FAIRFAX COUNTY

STAFF REPORT

APPLICATION RZ 2001-SU-055

PROPOSAL: To rezone 2.37 acres from R-1 (Residential, 1 du/ac) and WS Districts to R-3 (Residential, 3 du/ac) and WS Districts to permit development of 5 single-family detached dwelling units in a conventional subdivision at an overall density of 2.1 dwelling units/acre (du/ac).

FIG. 2

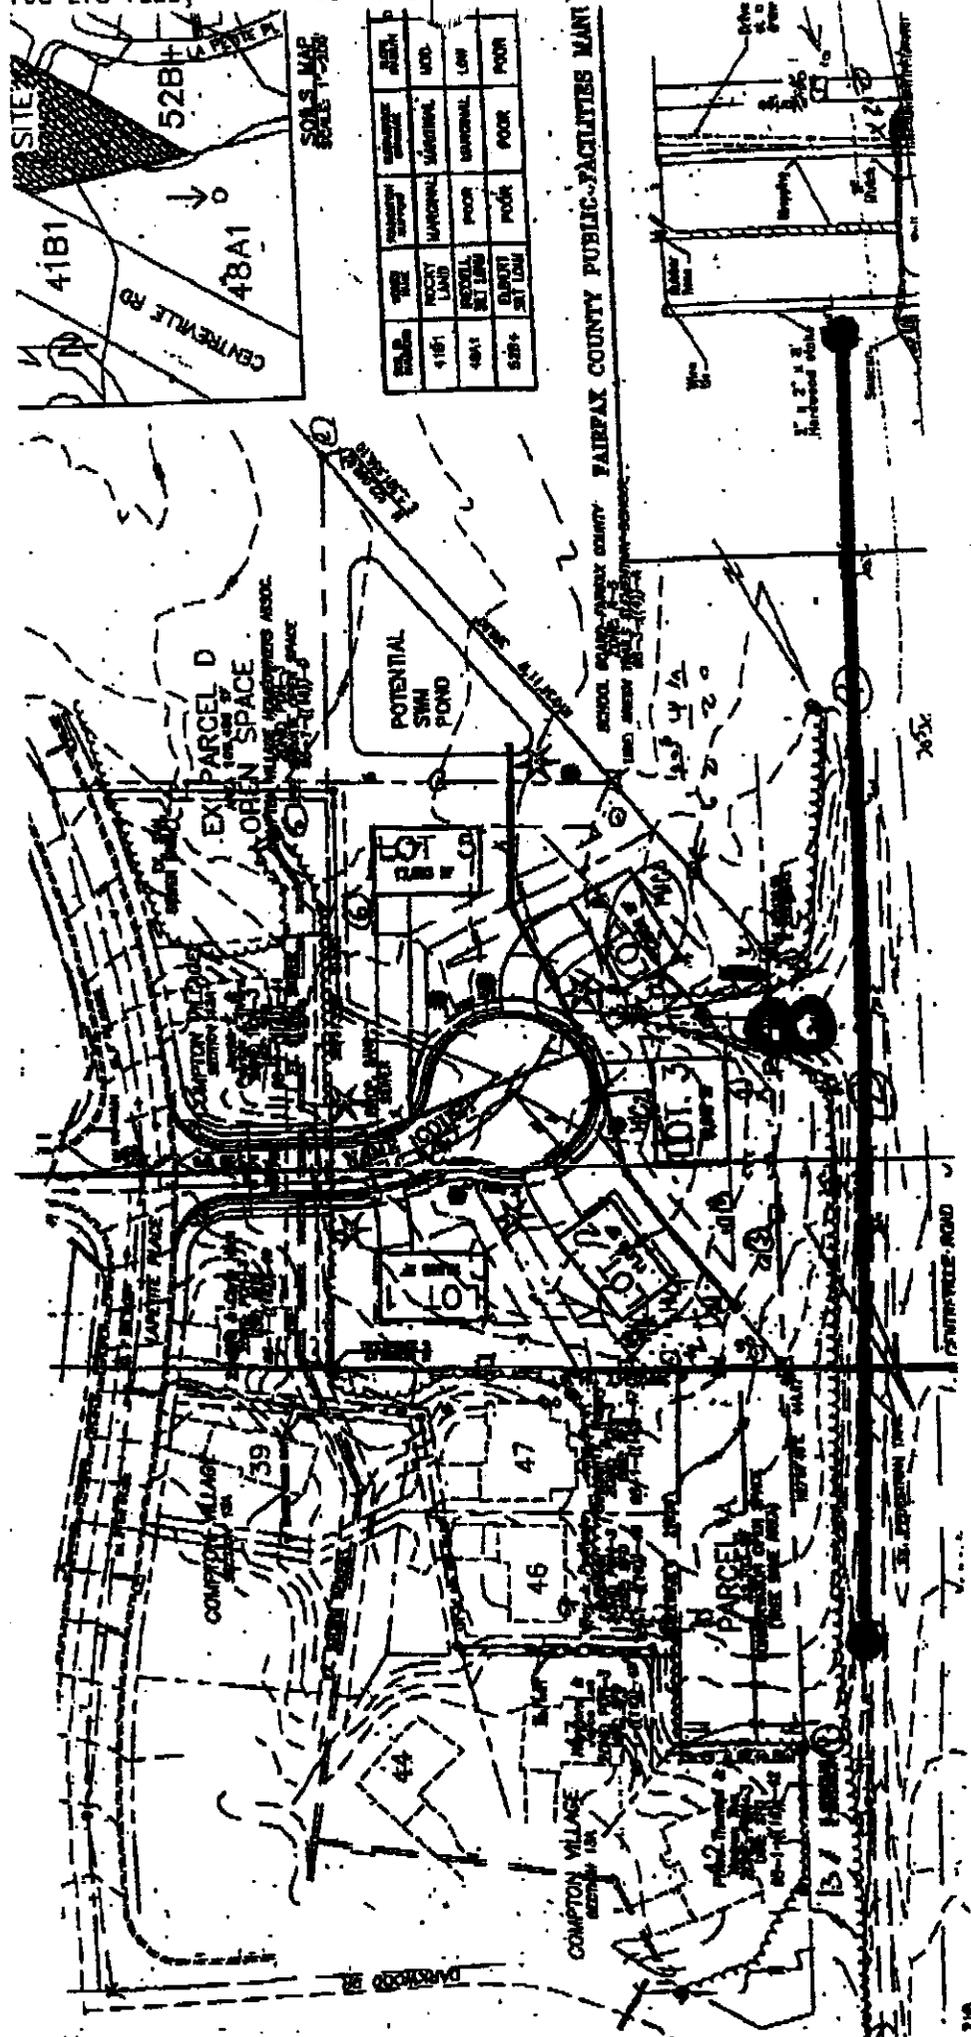
1. A noise barrier designed as shown in Figure 2. This noise barrier has a height of 8 feet above the existing ground elevation, is 720 feet long, and has an area of 5,761 square feet. With this noise barrier, the predicted DNL will not exceed 65 dB in the rear yards of any home or 75 dB at the top floor windows of any home. Note that this noise barrier was designed to reduce noise levels at rear yards and top floors. The proposed noise barrier can consist of any combination of noise walls and/or earth-berms.

FIG.3

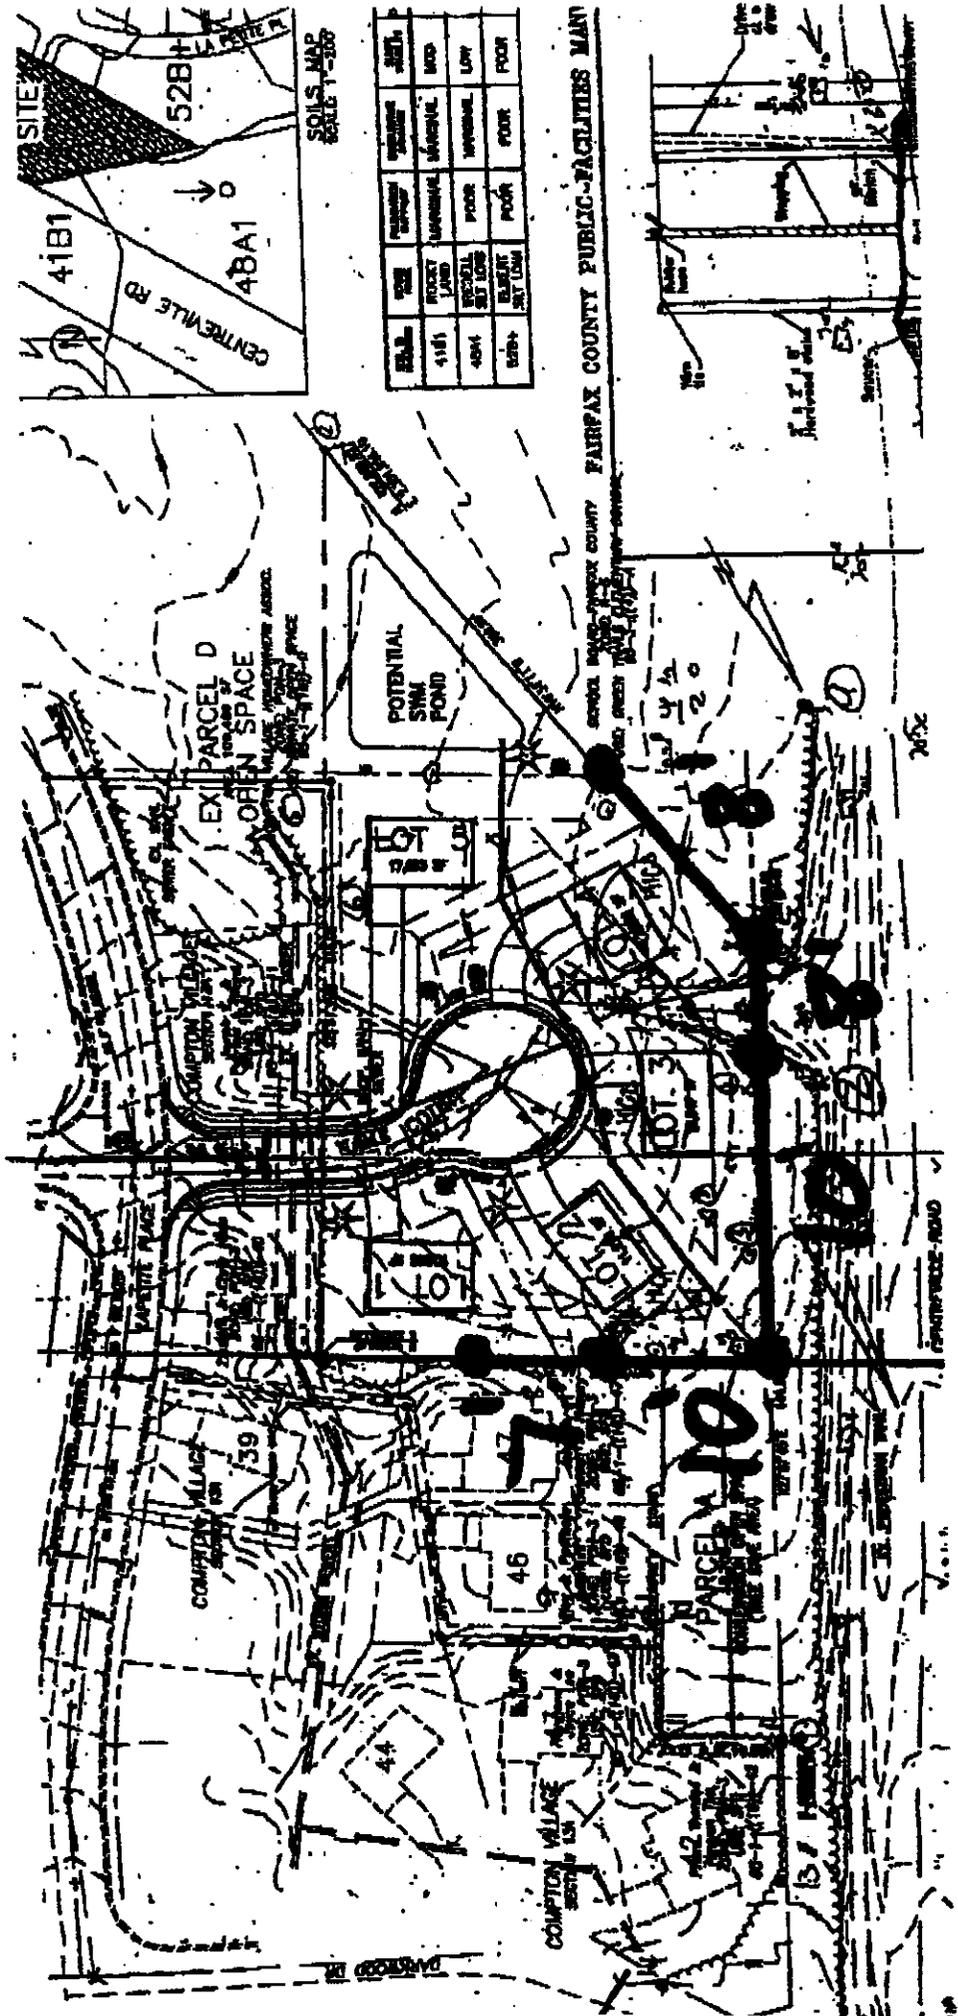
2. A noise barrier designed as shown in Figure 3. This noise barrier has a minimum height of 7 feet above the existing ground elevation and a maximum height of 10 feet. The barrier is 516 feet long and has an area of 4,554 square feet. Further, the ground elevations under lot 3 and lot 4 would need to be decreased by approximately 5 feet and 2 feet, respectively. The resulting first floor elevations would be 291 feet at lot 3 and 293 feet at lot 4. With these actions, the predicted DNL will not exceed 65 dB in the rear yards of any home or 75 dB at the top floor windows of any home.

3. A noise barrier designed as shown in Figure 3 (see above discussion). Further, the houses on lots 3 and 4 would have to be relocated to be further from the highway. If this option is of interest we can evaluate the necessary setback. With these actions, the predicted DNL will not exceed 65 dB in the rear yards of any home or 75 dB at the top floor windows of any home.

Figure 4. One Acceptable Wood Noise Wall Design.

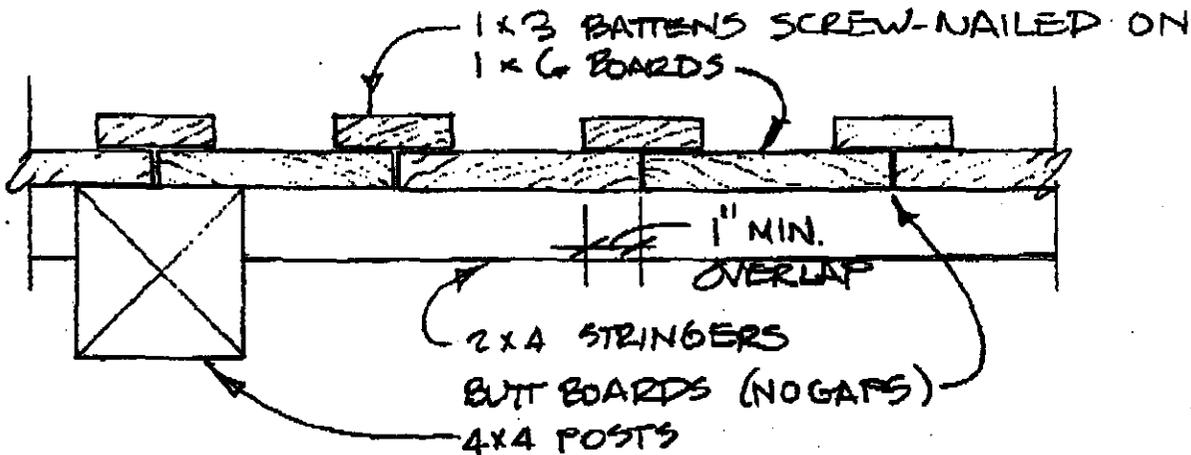
If a wood noise wall is proposed, one acceptable wood noise wall design is shown in Figure 4.
